CHANGE ORDER REQUEST

Project Name:	**Sumter County Supervisor of Elections**
Project Location:	332 Dr. Martin Luther King Jr. Ave Bushnell, FL 33513
Owner:	Board of Sumter County Commissioners
Architect/Engineer:	Harvard Jolly Architecture
General Contractor:	Mark Cook Builders
General Contractor Address:	511 N. Canal Street, Leesburg, FL 34748
Scope of Work:	Steel Changes per ASI #5 Slip Connections

DATE:	**10/28/24**
JOB NAME:	23-1918-S.C.S.E. ASI # 5 NEW TRUSS TO WALL CONNECTIONS

STEEL PROPOSAL/ CHANGE ORDER

DET. 1

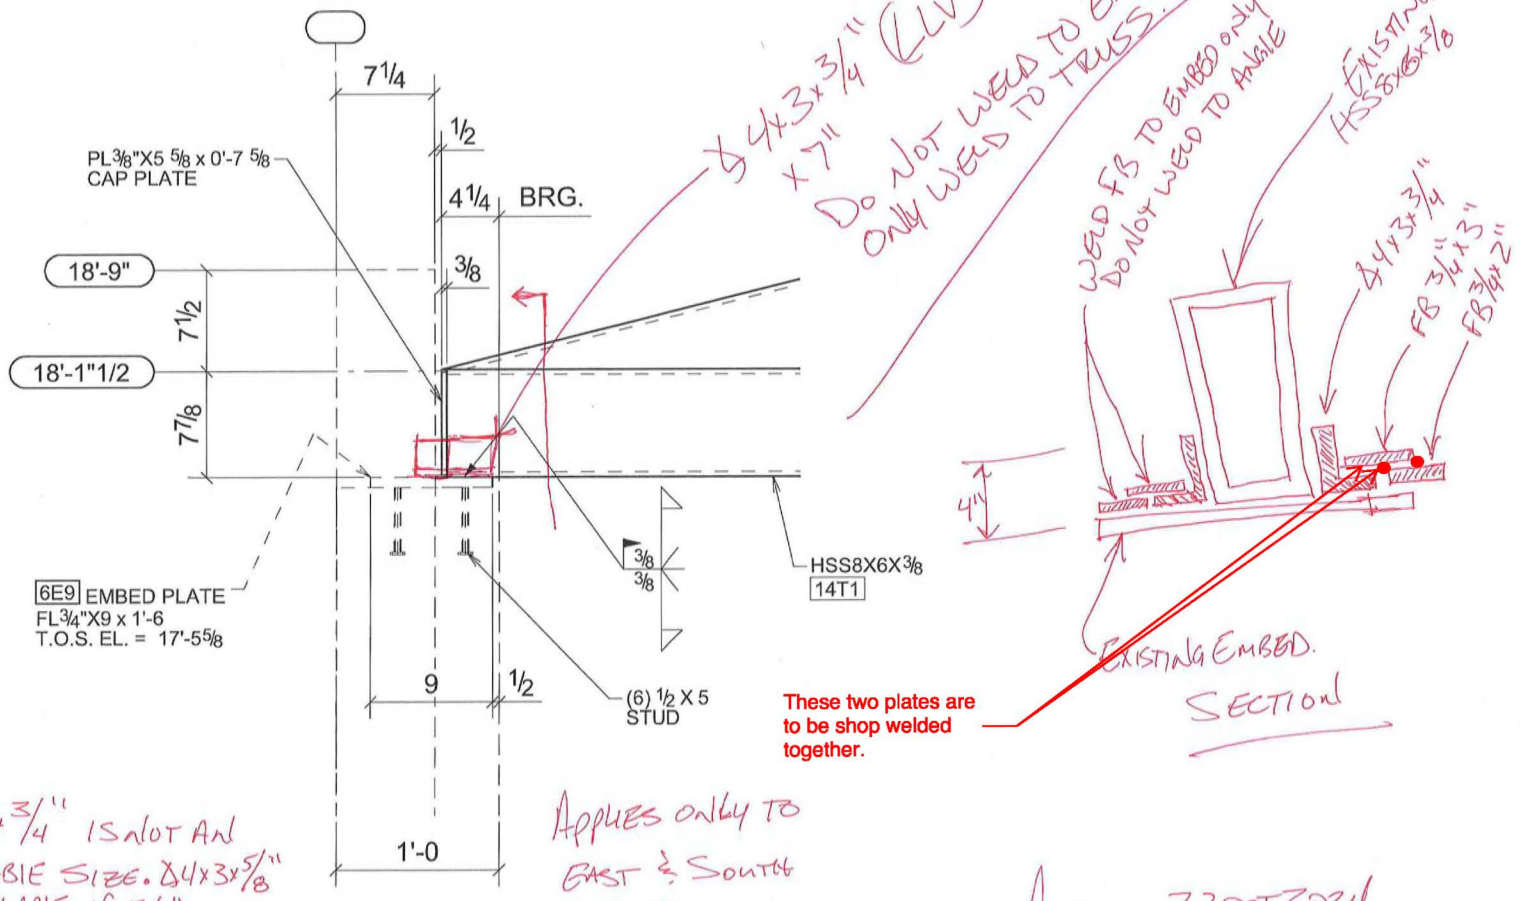
NEW "SLIP" CONNECTIONS AT ONE END OF EACH TRUSS (EAST AND SOUTH WALLS ONLY)

26ct ANGLES-2 AT EACH SIDE OF TRUSS *(ONLY FAB TIME IS CONSIDERED ON THESE AS ERECTION IS A WASH FROM ORIGINAL DETAIL)*
26ct "Z PLATES" SHOP FABRICATED

NOTE: L 4x3x3/4" IS NOT AN AVAILABLE SIZE. L 4x3x5/8" IS AVAILABLE. IF 3/4" IS REQUIRED, BENT PLATE WILL BE PROVIDED IN LIEU OF ANGLE.

APPLIES ONLY TO EAST & SOUTH WALLS.

3/4" is required.
